FA Bhatti Industries

Pakistan ACCORD for Health and Safety in the Garment and Textile Industry

Fire Safety Inspection Report

Pakistan Accord Initial Safety Inspection Report

Figure 2.16 - Unprotected opening into S4 from Building 4,5 &6.

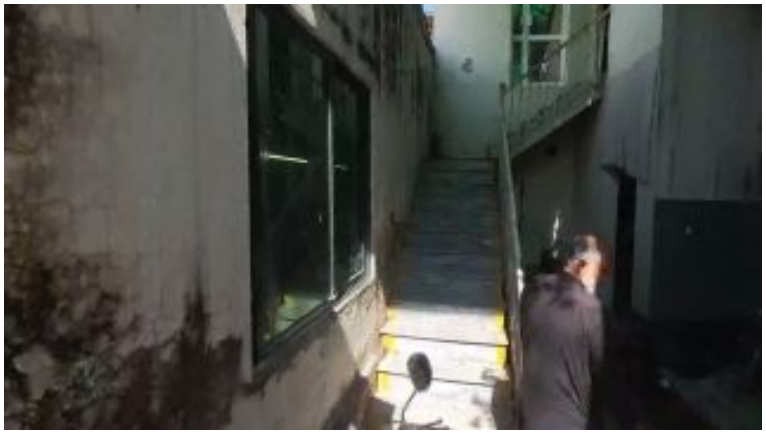
This is not always achieved, examples include (list not exhaustive):
- Unprotected openings into stairs such as unprotected opening into S2 from Building 7, S3 from generator area, S4 from Building 4, 5 & 6 and S5 from Building 4.
- Missing fire rated enclosure and fire doors in stair S6, S8 and S9.
- Fire load under stairs S1 & S4, fire load and obstruction in S3 first floor.

Timeline	Remediation Plan
Immediate CAP-0076759	Remove fire load and any other obstructions due to stored items from stairs.
Medium Term CAP-0076760	Prepare drawings showing proposed fire separating construction to protect stairs. These shall be submitted to Pakistan Accord for review and approval prior to rectification works. The drawings should cover: - Layout showing the location of fire rated walls /doors to protect the stairs. - Details of proposed fire resisting walls and fire door assemblies (e.g. fire door listing, fire rating period, self-closers, door opening direction, details of the door opening mechanism and locks). - Location of stair discharge routes and details of fire resisting construction to protect that route.
Longer Term CAP-0076761	Ensure all emergency escape stairs are fire separated from the rest of the building using 2 hours fire separating construction with 90-minute fire doors. The design shall follow Building code of Pakistan Section 10.3.2.1. Key requirements include: - All doors into stairs should be fire resisting doors with self-closing mechanisms. - Penetrations through doors are not permitted. - Doors into stairs should be kept closed (but not locked) at all times.
